API Comments on: *Sequestering Carbon Dioxide in a Closed Underground Volume*^{1,2}

Background:

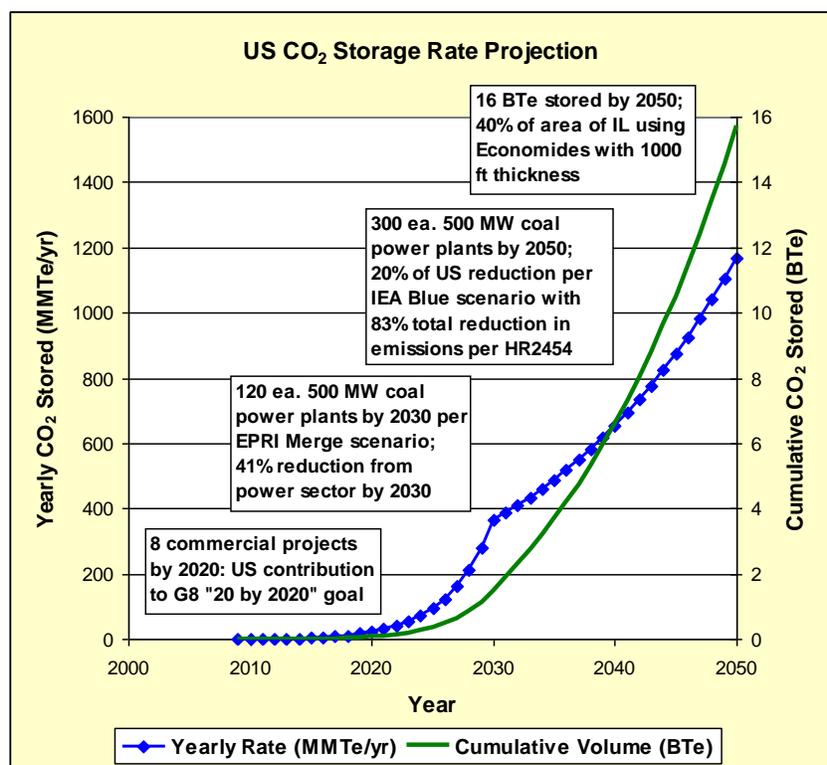
When realistic reservoir thickness is assumed – even without addressing the “closed” reservoir assumption – their conclusions are reversed.

As shown above, the authors’ method yields a reasonable estimate of the size of reservoir needed for a project – again recalling the assumption of a closed reservoir. Taking the analysis a step further, we can consider the implications for the CO₂ to be stored in the US between today and 2050. The graph below illustrates that, given assumptions drawn from accepted projections by G8, EPRI and IEA, around 16 gigatonnes of CO₂ will need to be stored in the US in order to reach GHG emissions reduction goals envisioned in current US legislation. If all this CO₂ were to be stored in the Illinois basin, based on the calculations above, around 23,500 mi² of storage space would be utilized, or around 40% of the area of Illinois. This indicates that the Mt. Simon formation in the Illinois basin – just one of many prospective storage sites in the US – is sufficiently large to store all the CO₂ required to be eliminated through CCS

between today and 2050. *The authors' analytical method can therefore be utilized to prove the opposite conclusion to the one they make in the paper; namely, that management of CO₂ emissions through utilization of CCS in a portfolio of energy technologies is eminently feasible.*
